**Addendum No. 3**  
Page 1 of 21

Joliet Junior College  
1215 Houbolt Road  
Joliet, IL 60431

**TO:** Prospective Respondents  
**SUBJECT:** Addendum No. 3  
**PROJECT NAME:** Renaissance Center Interior Renovations  
**JJC PROJECT NO.:** B16008

A221-01

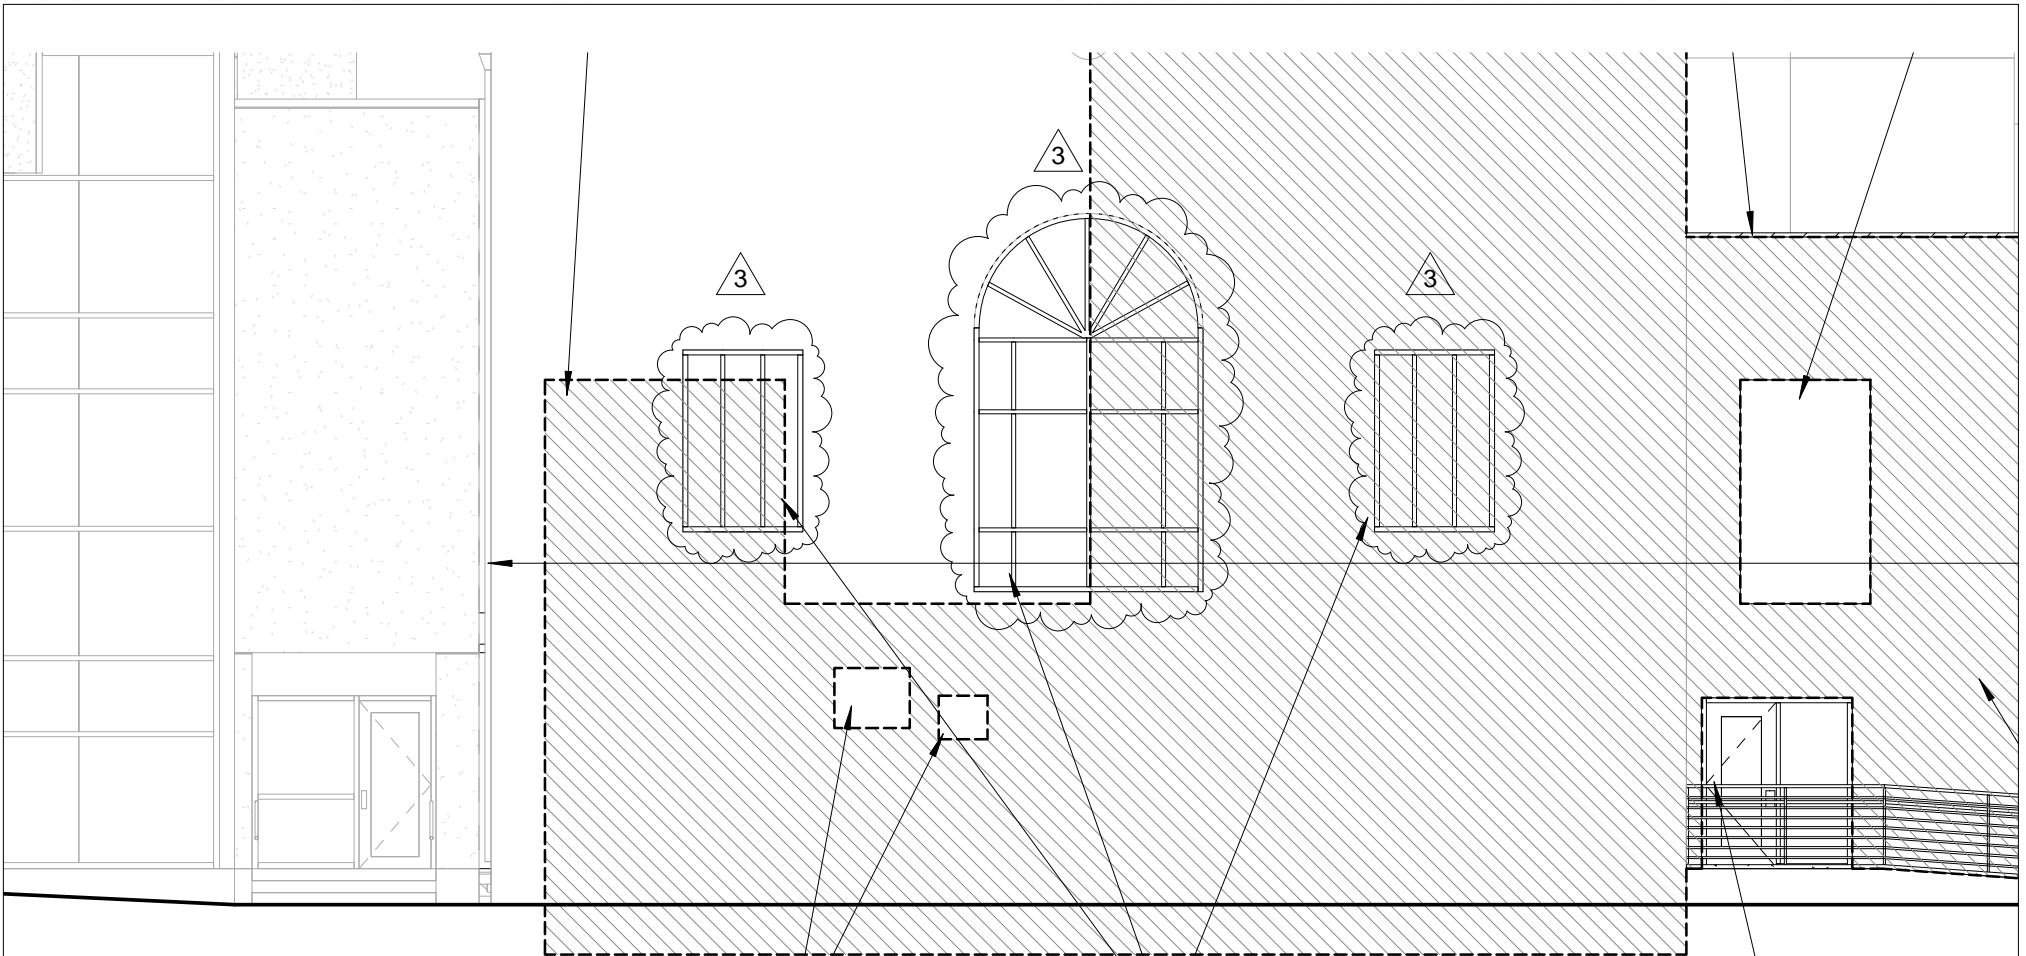
- G. Sheet A1.21: **REVISE** per attached sketch **A121-01**
- H. Sheet A2.21:
- 1) **REVISE** per attached sketch **A221-01**
  - 2) **REVISE** ceiling type 5 to read "ACOUSTICAL PLASTER CEILING SYSTEM ON METAL STUD FRAMING"

INFILL STUCCO AT REMOVED  
DUCTWORK - REFER TO WALL  
SYSTEM SHOWN IN 9/A7.52  
FOR INFILL - VERIFY  
OPENINGS IN FIELD

A401-01

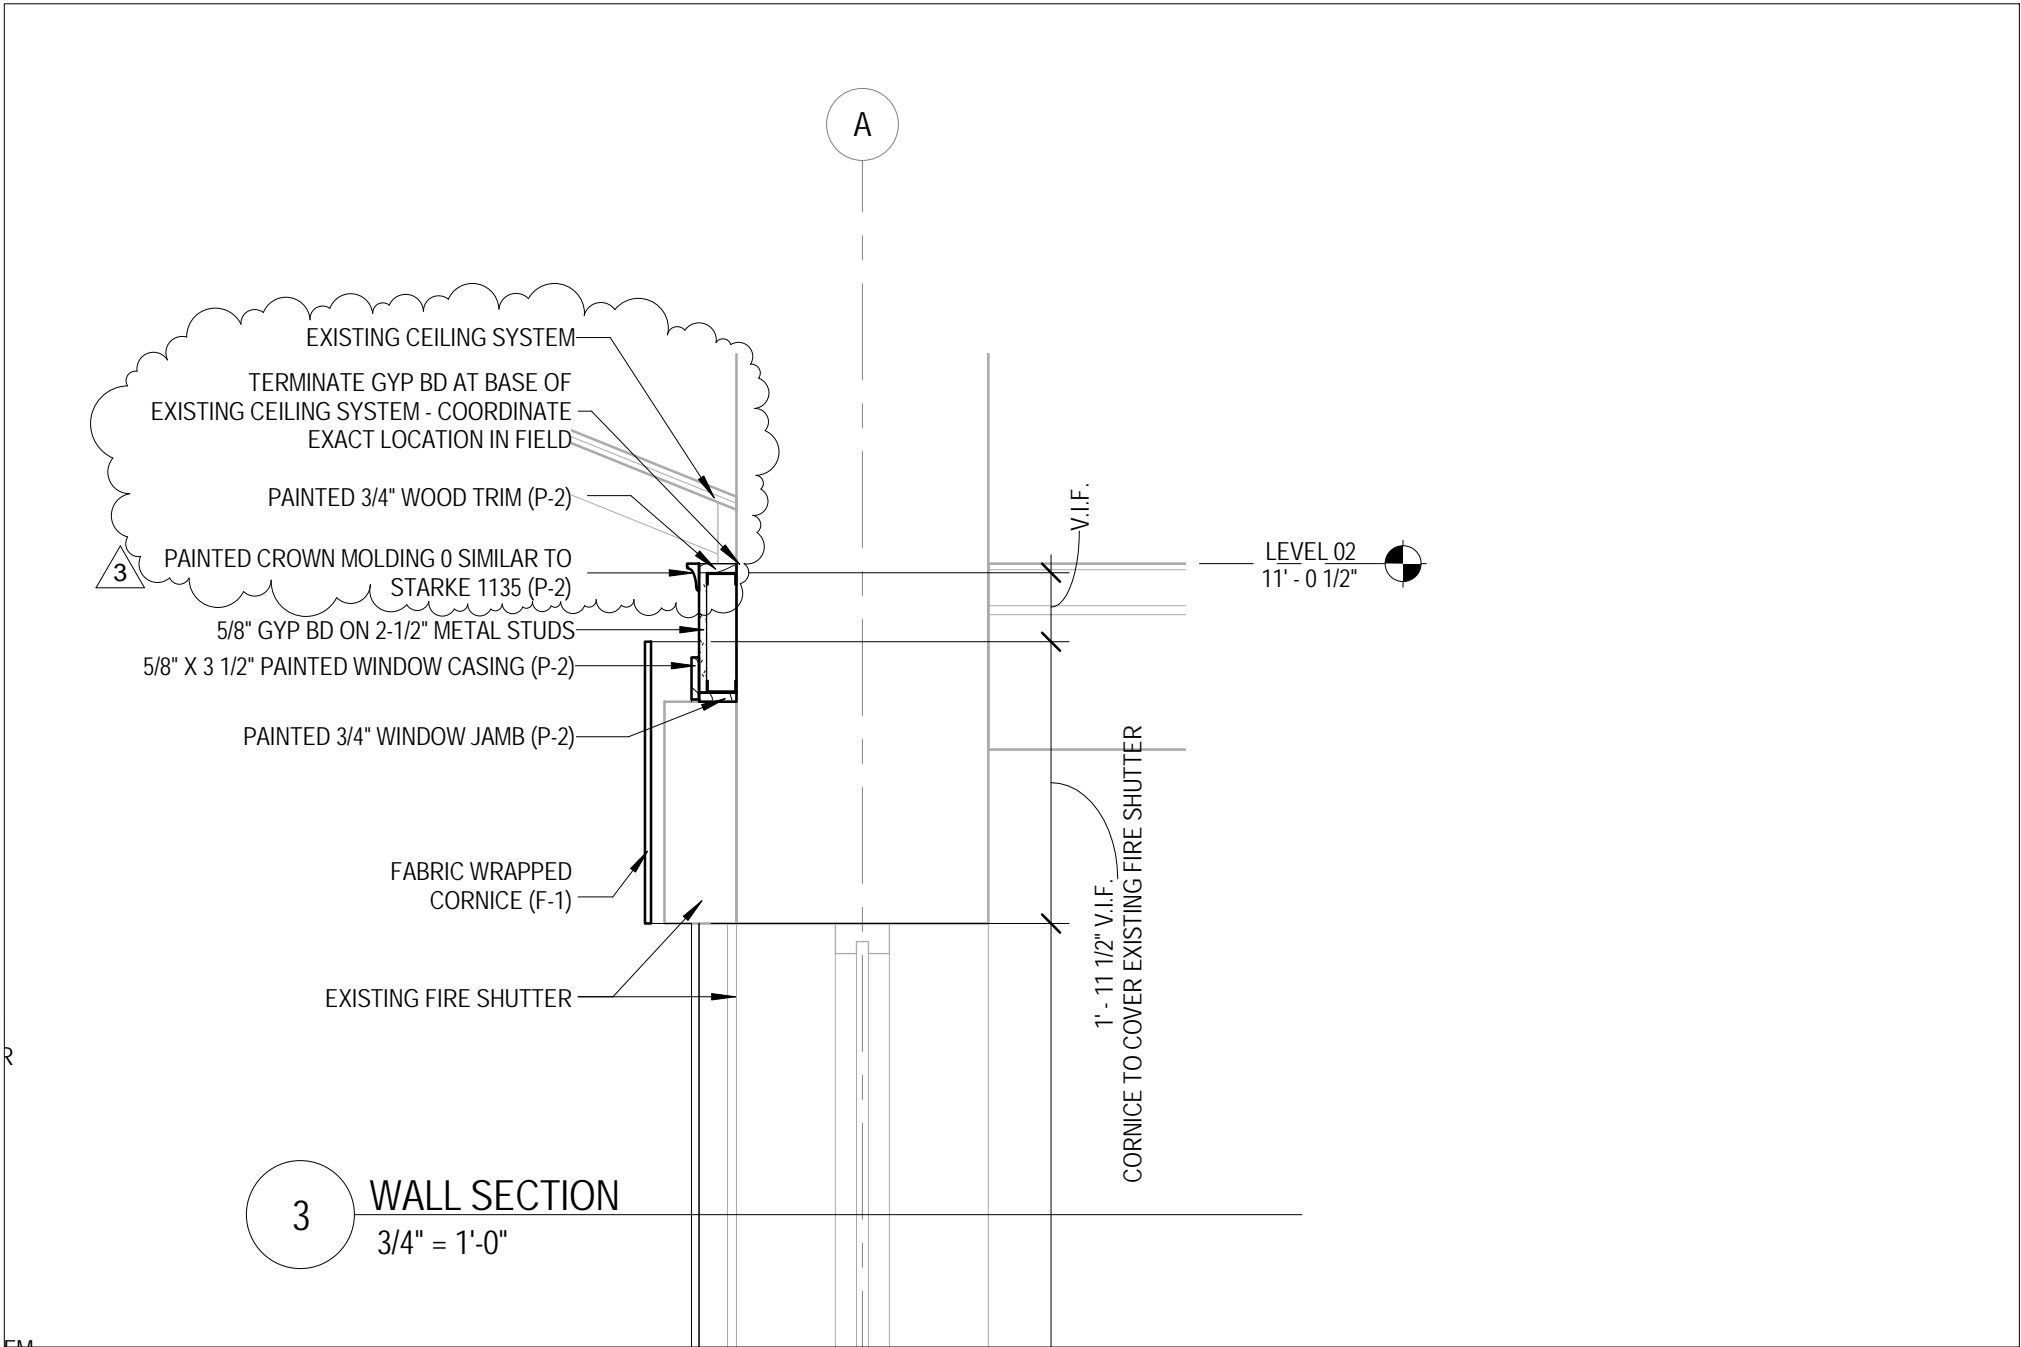
- 3) **REVISE** ceiling type 6 to read "PLASTER CEILING SYSTEM ON METAL STUD FRAMING"
- I. Sheet A4.01: **REVISE** per attached sketch **A401-01**
- J. Sheet A6.01 and A7.01: **REVISE** keynote that reads "3 HR FIRE RATED DOOR – N.I.C." TO READ "3 HR FIRE RATED DOOR" in all locations it exists on these sheets

A602-01

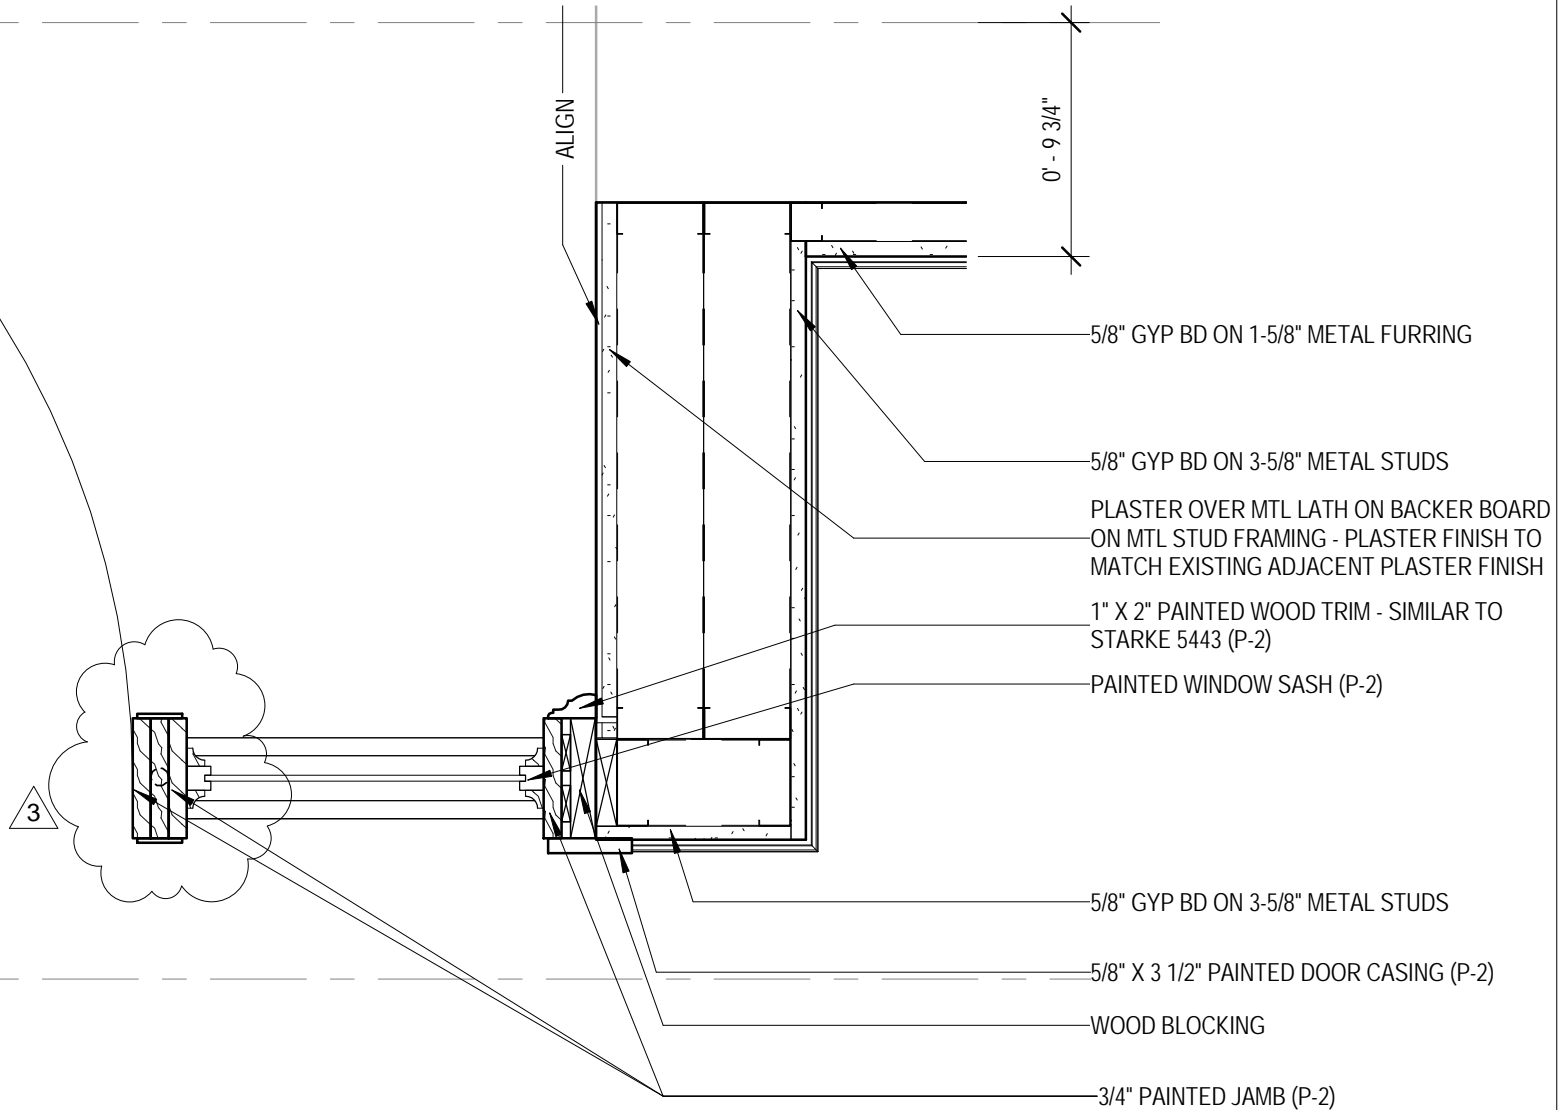
- K. Sheet A6.02: **REVISE** per attached sketch **A602-01**

A751-01

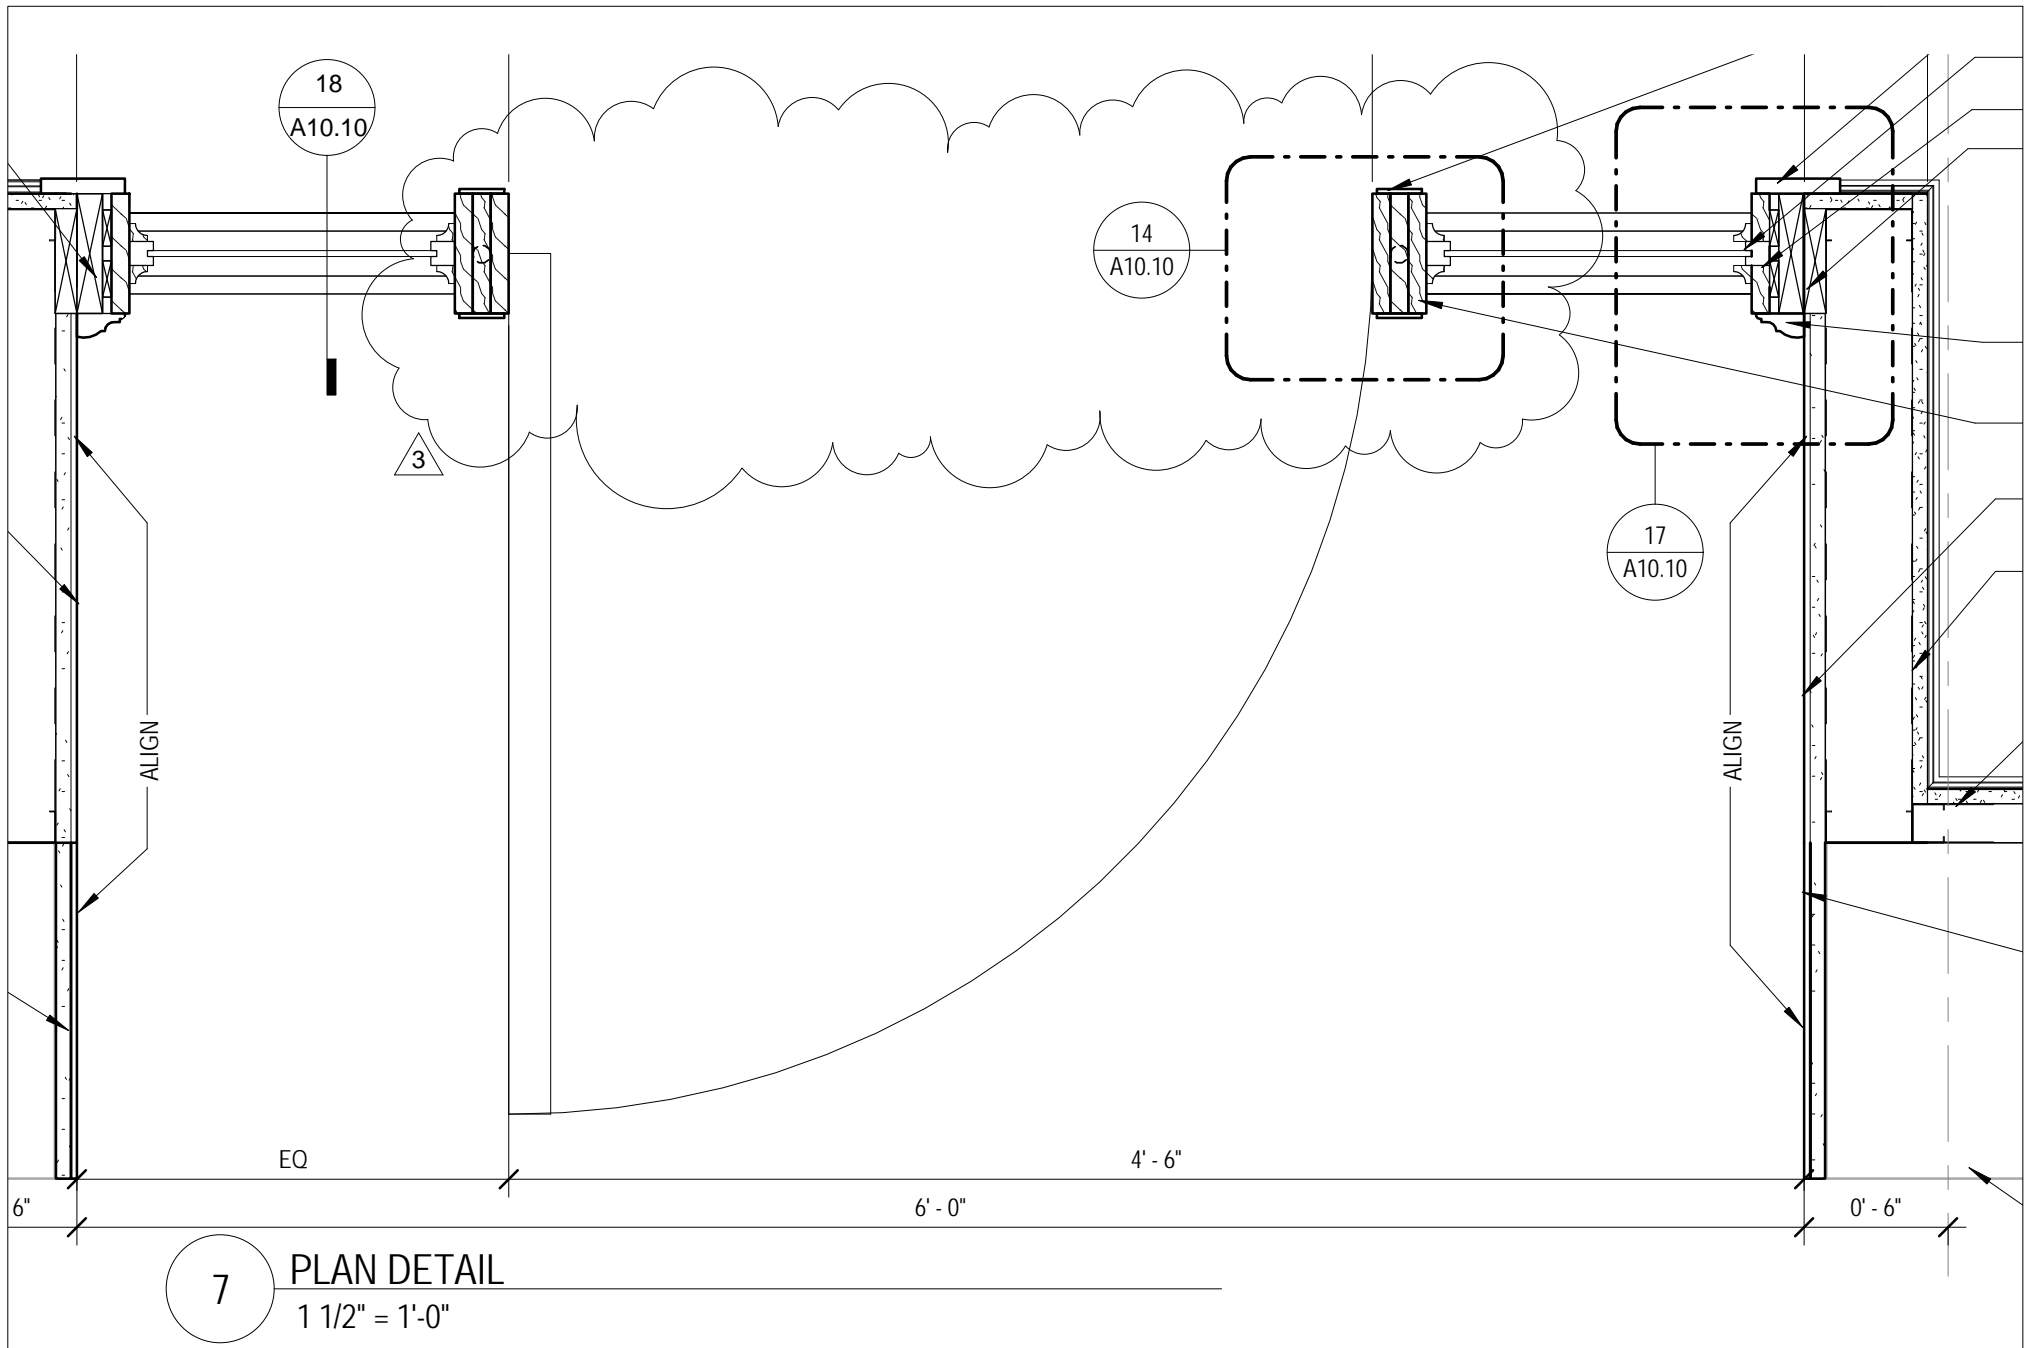
- L. Sheet A7.51: **REVISE** per attached sketches **A751-01 and A751-02**
- M. Sheet A7.52: **REVISE** per attached sketches **A752-01**
- N. Sheet A9.01: **REVISE** per attached sketches **A901-01 and A901-02**
- O. Sheet A10.01: **REVISE** per attached sketch **A1001-01**
